# SERVICE PARTS LIST

SPECIFY CATALOG NO. AND SERIAL NO. WHEN ORDERING PARTS		REVISED BULLETIN 54-38-1600	DATE Aug. 2007
<b>9" GRINDER</b>			
CATALOG NO.	<b>6086-20</b>	SERIAL NUMBER	<b>991B</b>
		WIRING INSTRUCTION <b>58-01-1370</b>

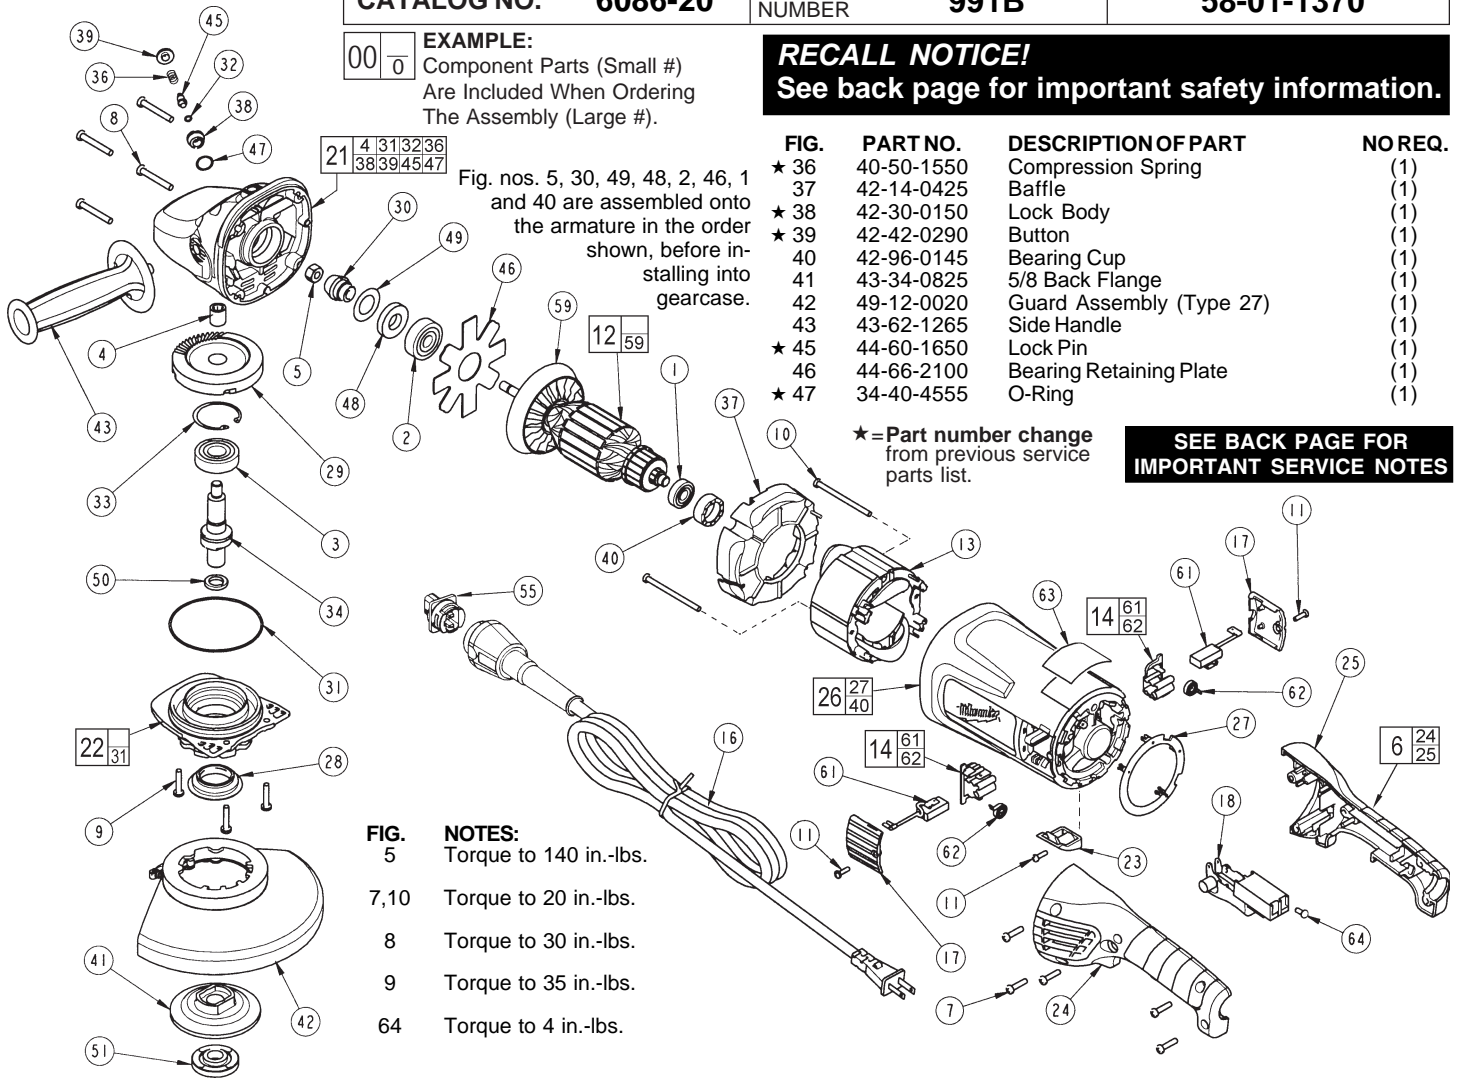
**31-50-1752 Motor Housing Kit** incorporates changes to the shielding of the armature pinion and commutator ball bearings along with the retaining of the pinion ball bearing into the gearcase assembly of 7"/ 9" 15Amp Sander / Grinders - 6080-20, 6081-20, 6082-20, 6086-20, 6088-20 and 6089-20.

Additionally, a change has been made to the motor housing and wiring of the tool. The ATF field coil is now 'hard-wired' with four [4] new leadwire assemblies, see **Wiring Instruction 58-01-1371**. Add 'X' Grease, 49-08-5000 to mag-mate field terminals as need.

Motor Housing Kit consist of:	Discarded Parts:	Model Affected
2ea <b>06-75-0510</b> ¼-20 Hex Screw* <i>item 15</i>		All
1ea <b>45-06-0830</b> Bearing Seal <i>item 19</i>		All
1ea <b>31-50-1785</b> Motor Housing <i>item 26</i>	31-50-1751 Motor Housing	All
1ea <b>31-53-0160</b> Plug**	31-53-0160 Plug*	All
1ea <b>31-55-0290</b> Dust Shield <i>item 35</i>		All
1ea <b>44-86-0040</b> Bearing Retainer <sup>A</sup> <i>item 46</i>	44-66-2100 Bearing Ret Plate	All
1ea <b>23-94-9300</b> LeadWire Assembly	23-94-2650 LeadWire Assy	All
1ea <b>23-94-9305</b> LeadWire Assembly	23-94-2655 LeadWire Assy	All
1ea <b>23-94-9310</b> LeadWire Assembly		All
1ea <b>23-94-9315</b> LeadWire Assembly		All
	42-96-0145 Bearing Cup	All

<sup>A</sup> Service Note - 'check for slip fit' - mounting of 02-04-1680 Ball Bearing to the armature shaft may require removal of a 0.0001" - 0.0002" from the O.D. of the armature pinion end ball bearing journal - it is recommended to use emery cloth and armature lathe to lightly sand, for a few seconds, removing the material necessary for the pinion shaft to be a 'slip fit through the pinion ball bearing' as it is being held in place in the GearCase by the 44-86-0040 Bearing Retainer.

Stamp or etch an 'R' in the tool's nameplate next to the catalog number after installation of the 'current production' service replacement parts listed above.

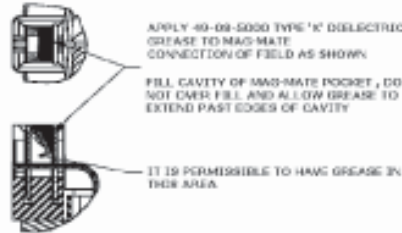
**The original equipment switch (23-66-2710 / 23-66-2720) should be replaced with a new re-worked 23-66-2720.** Reworked switches will have a white dot (indelible paint) applied to the location at the base of the switch (see illustration).

If the nameplate has an **'X'** stamped into the tool's nameplate, next to the serial number, the tool has been repaired and the defective switch has already been replaced.
